Attorney's Docket No.: 07977-093002

REMARKS

2/6

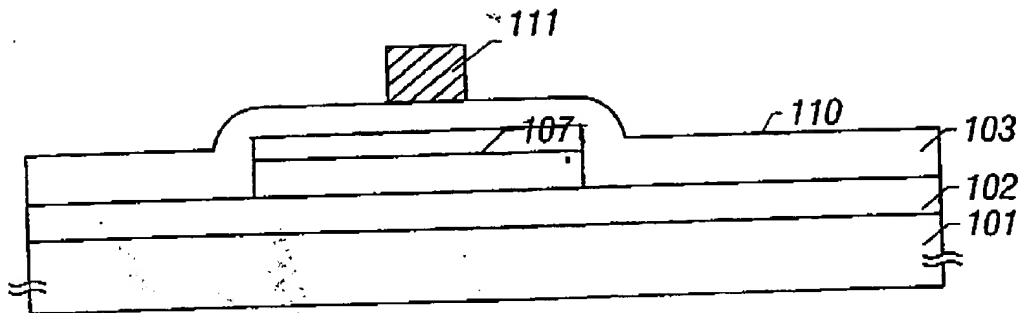
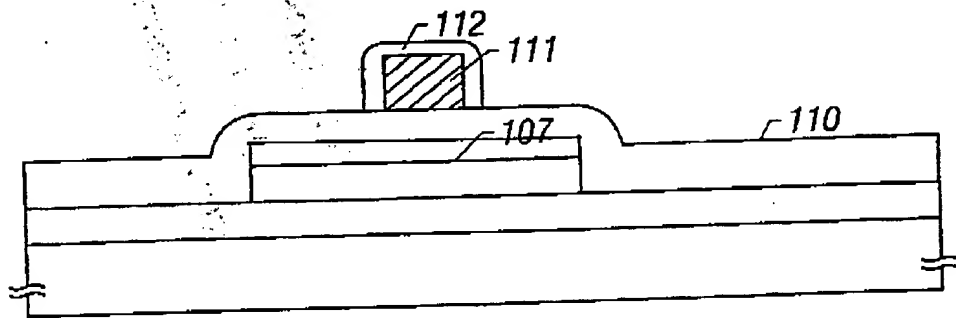
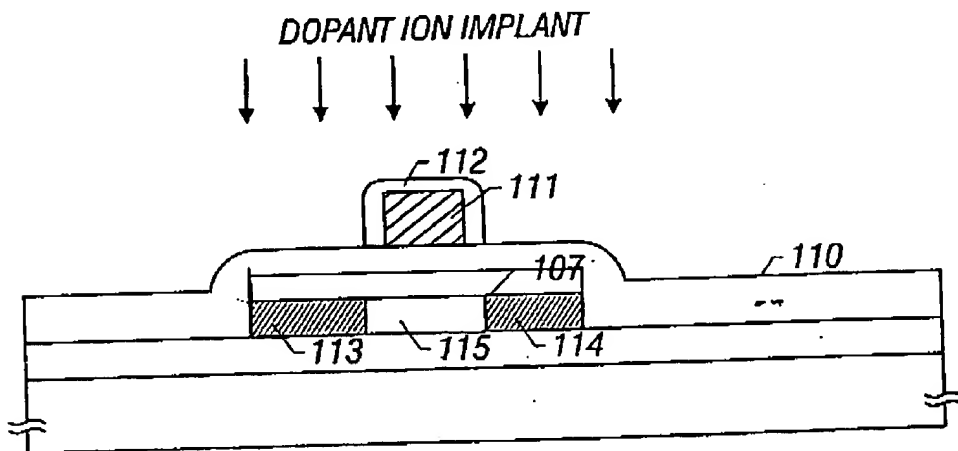
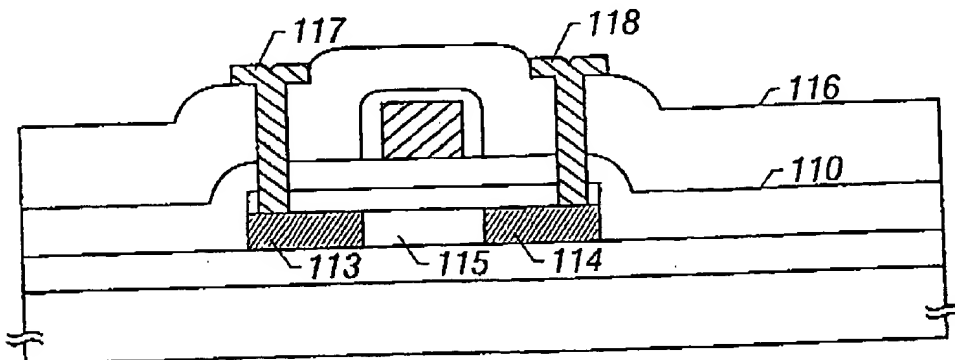
The drawings stand rejected under rule 83. In response, Figures 2A - 2D have been amended to clarify their subject matter and to show the claimed invention more clearly.
